The Columbia Architectural Design Review Team will meet on Tuesday, January 17, 2023 at 9:00 AM in Conference Room A on the basement level of City Hall, 700 N. Garden Street. The Planning Commission will consider the following:

City of Columbia
ARCHITECTURAL DESIGN REVIEW TEAM
December 13, 2022

PROJECT DESCRIPTION: 732 Armstrong Lane Building

**PROJECT DESCRIPTION: Façade
Modification**

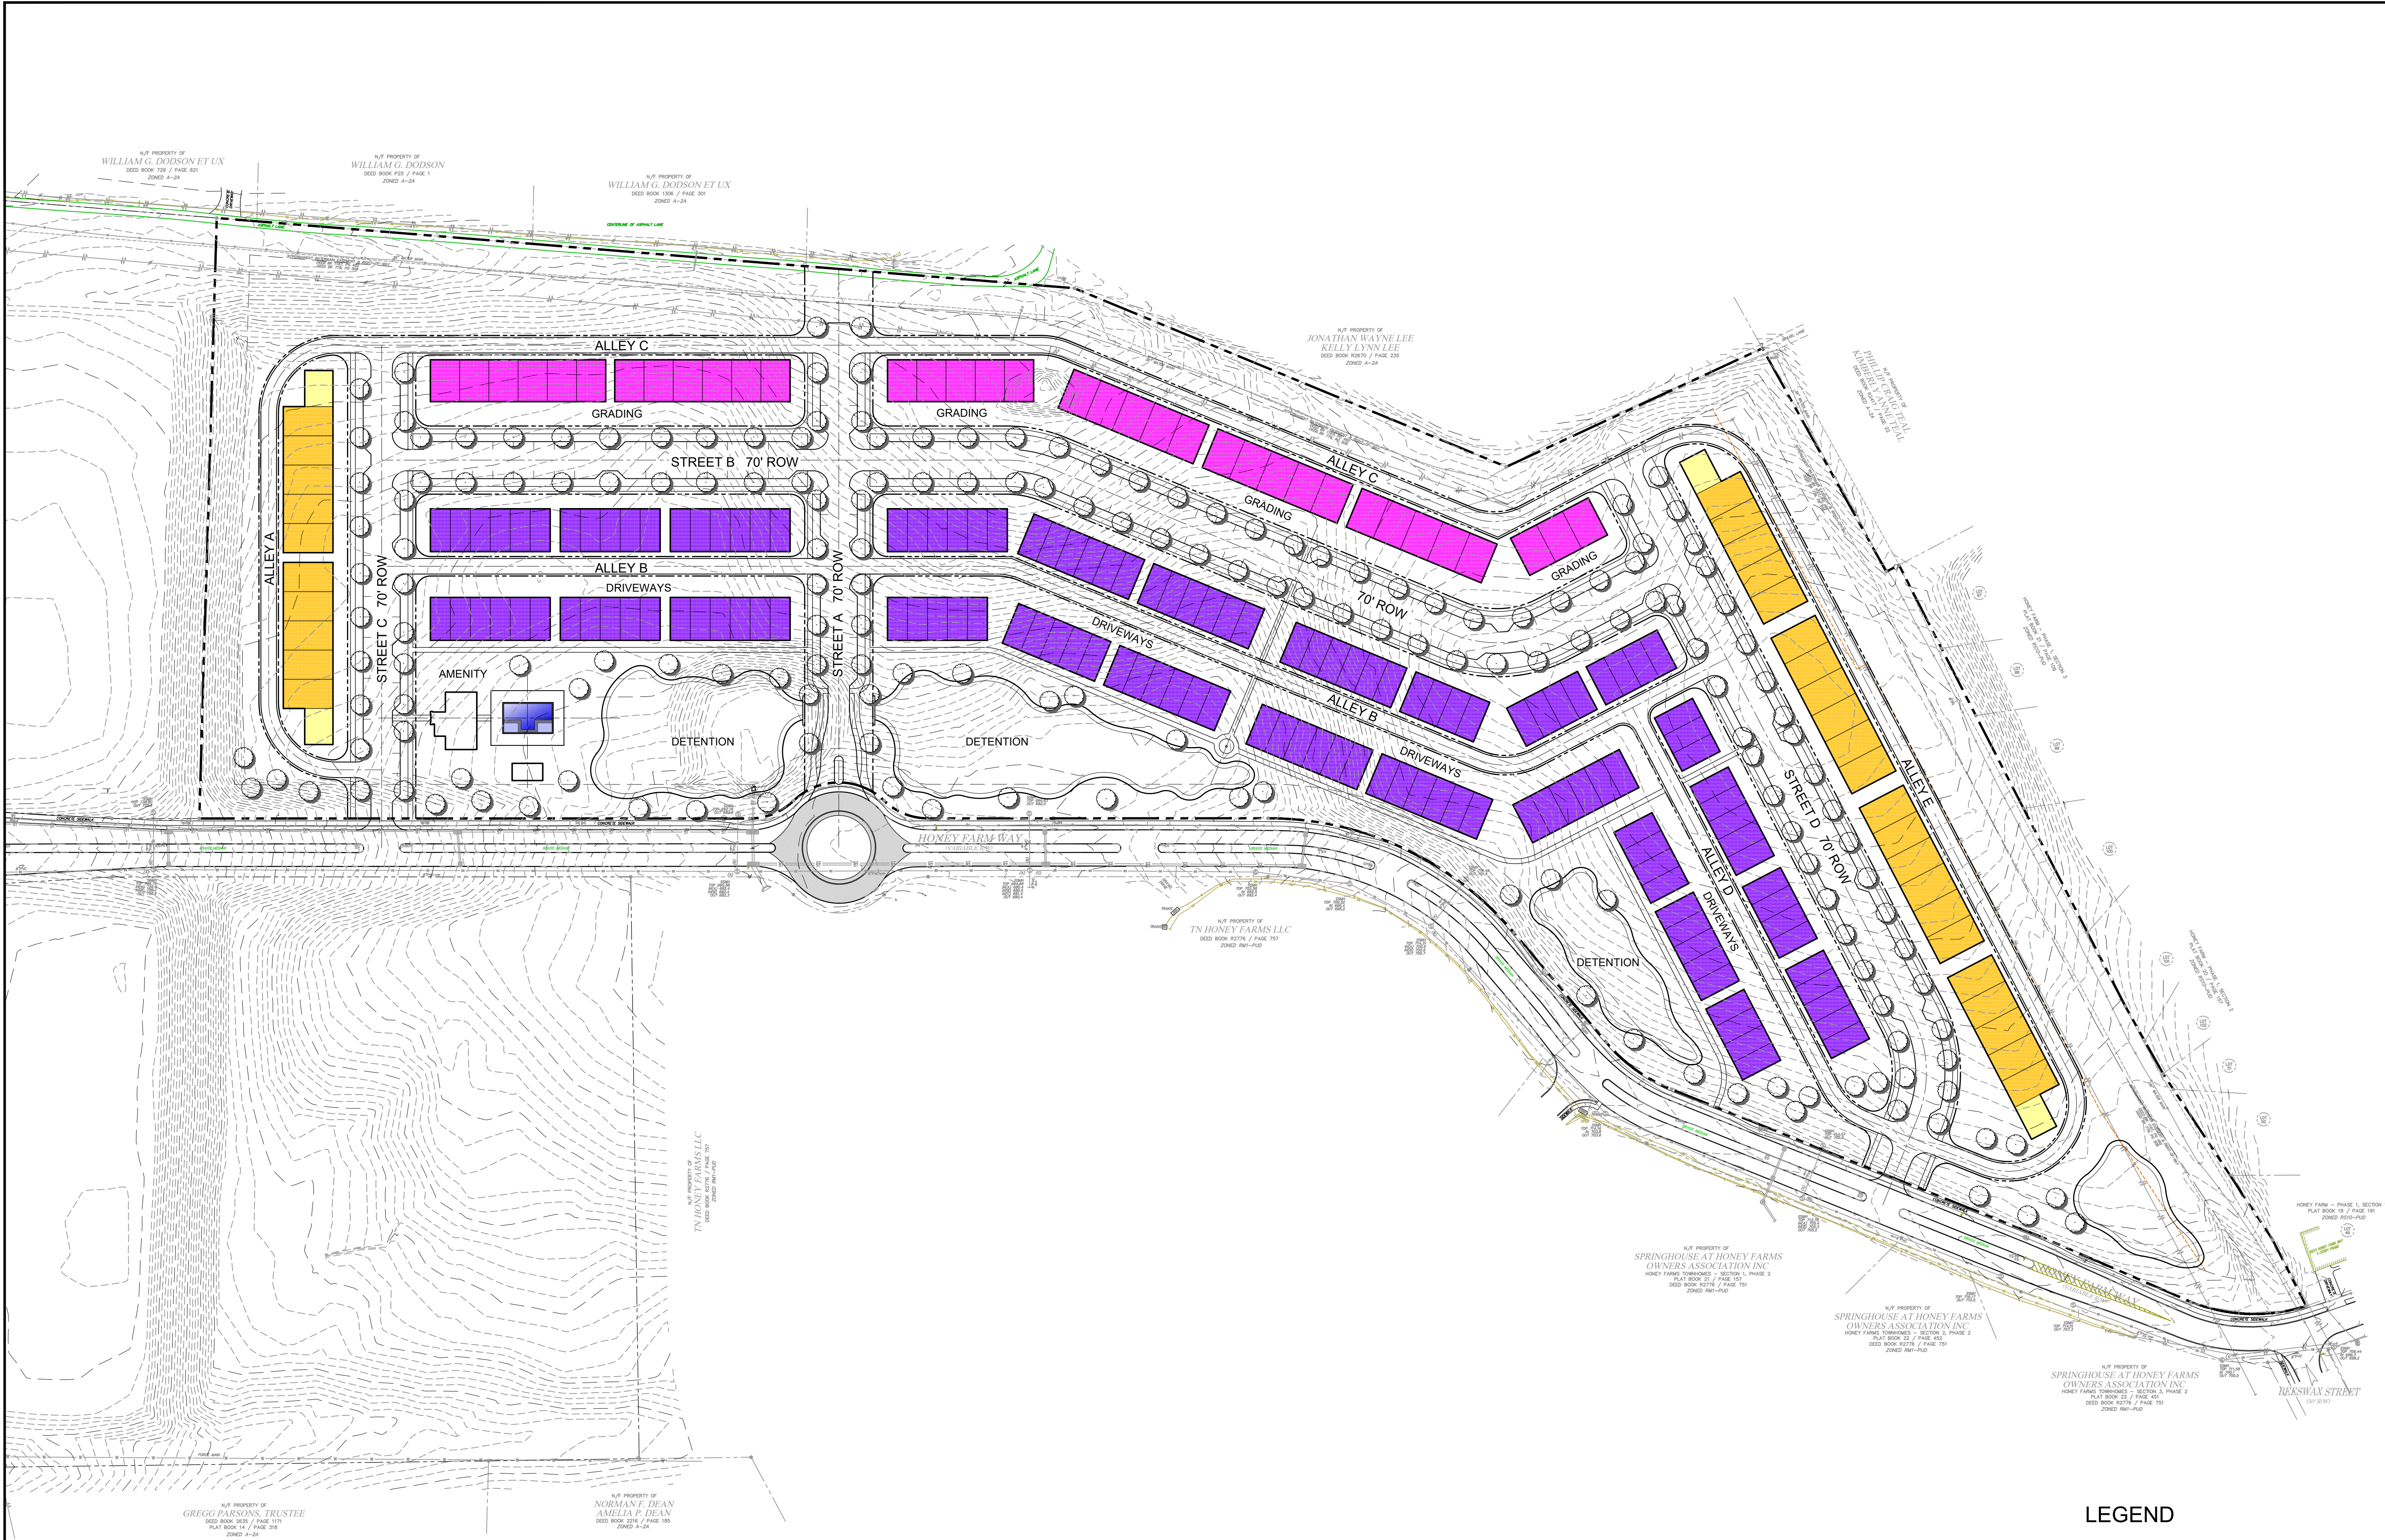
- Primary building materials on façade consist of cementitious siding and brick that are permitted materials on primary building facades.
- Façade articulation is required for a façade greater than 100'. The applicant has selected to achieve this articulation with the use of multiple colors with a material change of a combination of fiber cement board and white brick.

- All elevations require a foundation cladding of brick or natural stone. Multiple elevations do not indicate this foundation cladding requirement. This would achieve the building composition requirement of having a defined base, middle, and cap.

- Indicate details that's show minimum 6' clear depth for porch frontages.
- Façade variety is indicated as being broken up by color, noting that no more than one façade shall be on the same block face or within view of the same façade.
